**GLADSTONE PLANNING COMMISSION REGULAR AGENDA
GLADSTONE CIVIC CENTER, 18505 PORTLAND AVENUE
Tuesday, April 16, 2024 – 6:30 p.m.**

2. Monthly Planning Report – March 2024
3. **PUBLIC HEARING:** DR-24-01, Expansion of Existing ICSB Building which includes addition of a new 1,500 sq. ft. second story on the existing building and addition of a new 3,900 sq. ft. 2-story building attached to rear of existing building. Removal of home at 420 W Arlington to add parking and landscaping. 430 W. Arlington, Tong Wu/ICSB – owner; Metro Planning, Inc. – Architect.

Application No.:	DR-24-01
Owner/Applicant:	Owner: Tong Wu (ICSB) Applicant: Jed Truett(Metro Planning, Inc.)
Project Location:	420 and 430 W. Arlington St., Gladstone OR, 97027; 22E19DD 08200 and 08300
Project Description:	Expansion of the existing ICSB building. Expansion includes the addition of a new 1,500 SF second story on the existing building and addition of a new 3,900 SF, 2-story building attached to the rear of the existing building. Removal of the home at 420 W. Arlington St. to add parking and landscaping.

Proposed Site Plan

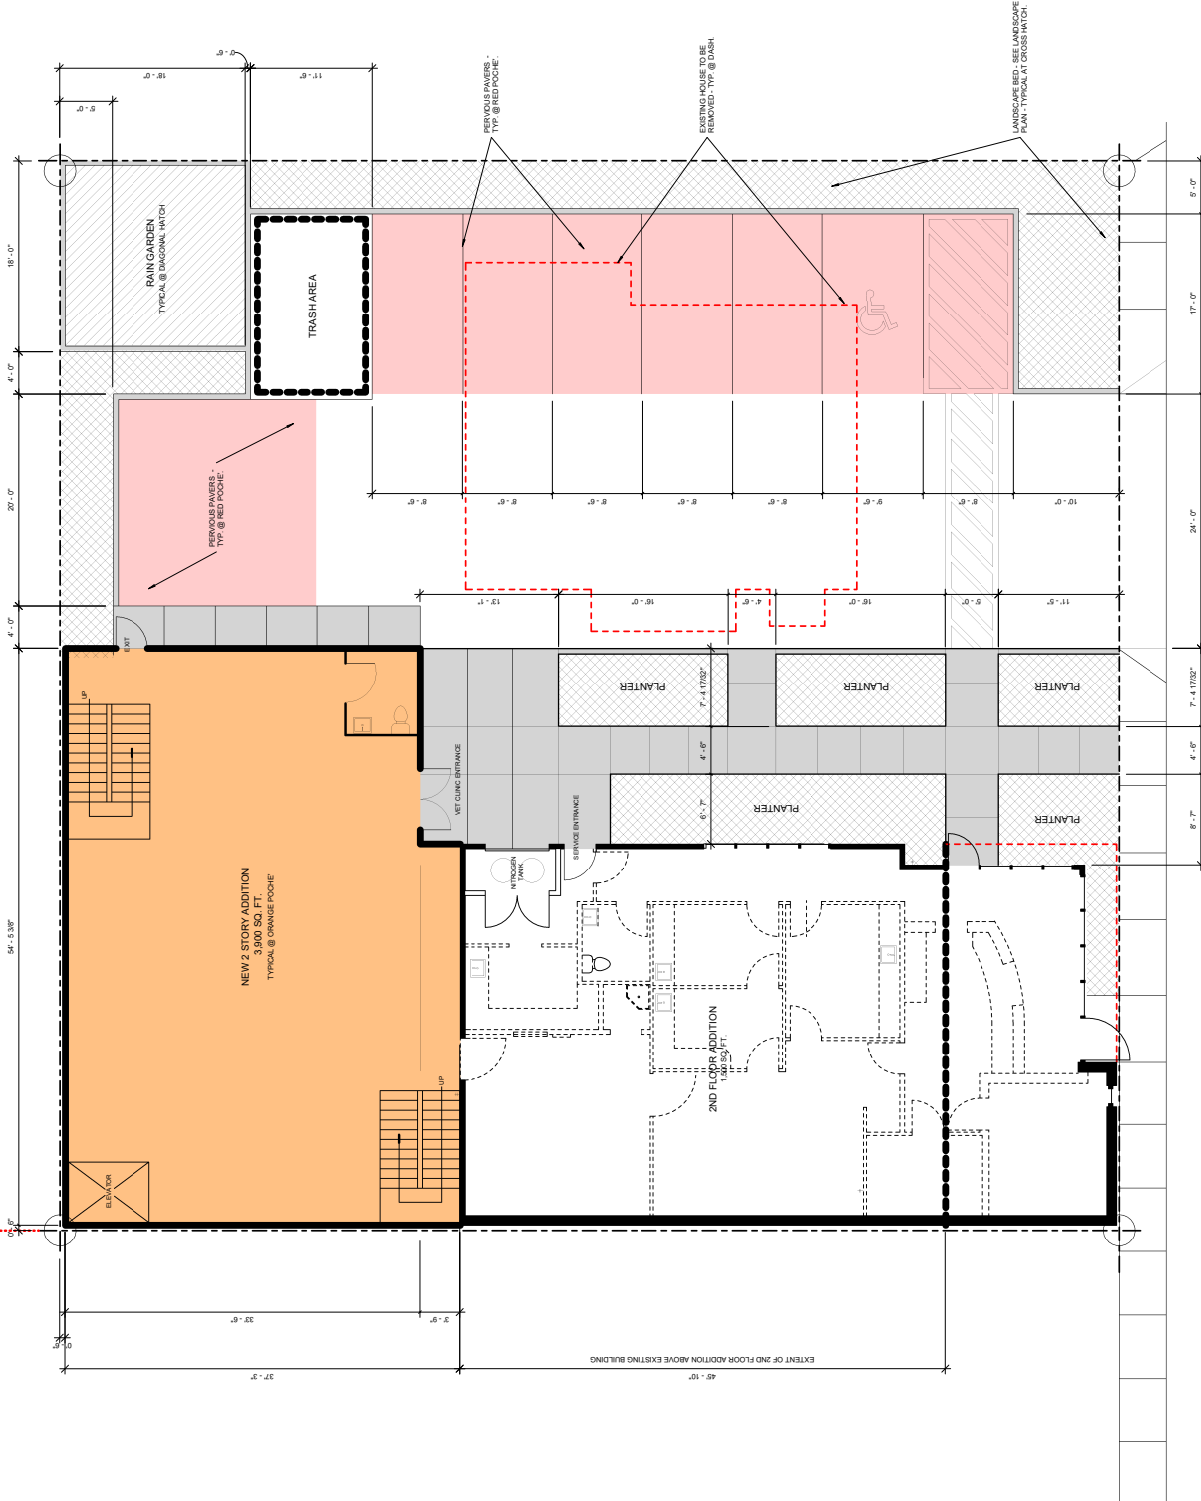
The site plan must be modified to increase the width of the landscaping strip separating the parking area from the neighboring property to the east to 5' (from the proposed 4'6"). The minor exceptions granted by this subsection do not include landscaping. GMC 17.46.020(2)(b) requires a landscaped strip a minimum of 5' in width separating a parking area from an adjacent property.

Therefore, the parking spaces would all need to be 16'6" deep, or the drive aisle reduced from 24' to 23'6", to accommodate a full 5' of landscaping, a 6" curb, parking and drive aisle without impacting the location of the building, pedestrian walkways or planter areas.

Finally, the portion of the drive aisle designated for "loading area" is within 5 feet of the residential zone to the rear. GMC 17.46.040(3)(d) states, "Loading facilities shall be located at least 20 feet from residential property." Staff recommends the Planning Commission approve a 5 foot (25%) minor exception to this requirement and the site plan be revised to include a 15 foot distance between the loading area and the adjacent residential property.

Finding: The site proposes six off-street parking spaces. The parking is separated from the street by a 9'6" landscaped strip. This should be widened to 10" per this standard. If necessary, the solid waste and recycling enclosure may be reduced in size to accommodate this 6" width. While not required, any provided parking must meet the city's design standards. The parking is separated from the lot to the east by a 4'6" landscaped strip and a 6" curb. Landscaping sheet LA-1 identifies the appropriate tree and shrubs in the landscaping strip separating the parking from the street. Fences are not proposed in the landscaped strip adjacent to the street and the parking area is under 3 acres in size.

Finding: A short-term bicycle parking rack for 2 spaces is provided on the site plan to the east of the vet clinic (see sheet C2.0, detail L). The details of the bicycle parking rack are provided on sheet C2.0. The design of the bicycle rack meets standards; however, the location is not within 30 feet of the main entrance and is shown in the middle of a pedestrian pathway. This standard may be met as conditioned.

3. **Revised site plan.** Prior to issuance of building permits, submit a revised site plan to Gladstone Planning Department which includes:
 - 5' wide landscaped strip (exclusive of curb) separating the parking area curb from the adjacent property to the east. This will result in either a reduction of the depth of parking spaces from 17' to 16'6" or a reduction of the width of the drive aisle from 24' to 23'6"

Condition: Prior to issuance of building permits, submit a revised site plan to Gladstone Planning Department which includes a 5 foot wide landscaped strip separating the parking area curb from the adjacent property to the east. This will result in either a reduction of the depth of parking spaces from 17' to 16'6" or a reduction of the width of the drive aisle from 24' to 23'6". In addition, revise the site plan to increase the space between the loading area and the abutting residential zoning to 15' in the rear of the property.

Condition: Prior to building permit approval, submit a revised site plan to the Gladstone Planning Department that demonstrates a minimum 10-foot-wide landscaped strip containing the materials listed in GMC 17.48.020(2)(c) in accordance with GMC 17.46.020(2)(b).

Condition: Prior to building permit issuance, submit a revised site plan to the Gladstone Planning Department identifying the bicycle parking rack within 30 feet of the main entrance.

Exterior Elevations

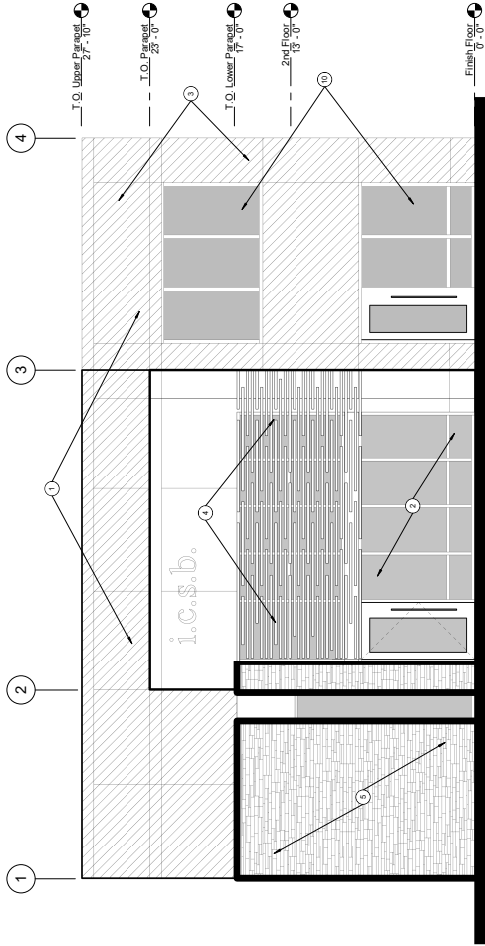
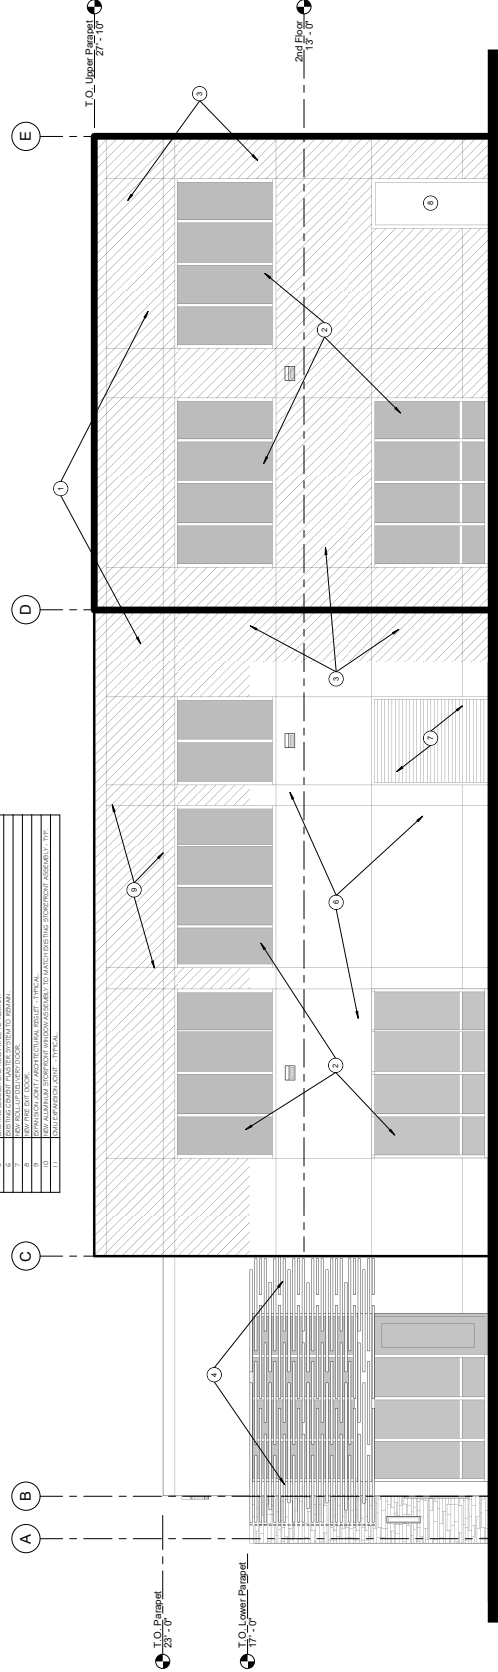
Finding: The submitted elevations show that additional lighting on the building addition will be added matching existing lighting on the eastern elevation. Pedestrian walkways and public entrances are lit by this on-building lighting. Parking area lighting is not indicated but can be conditioned. This standard is met as conditioned.

Condition: Prior to building permit approval, submit a photometrics plan for the parking area in accordance with GMC 17.44.020(5)-(6).
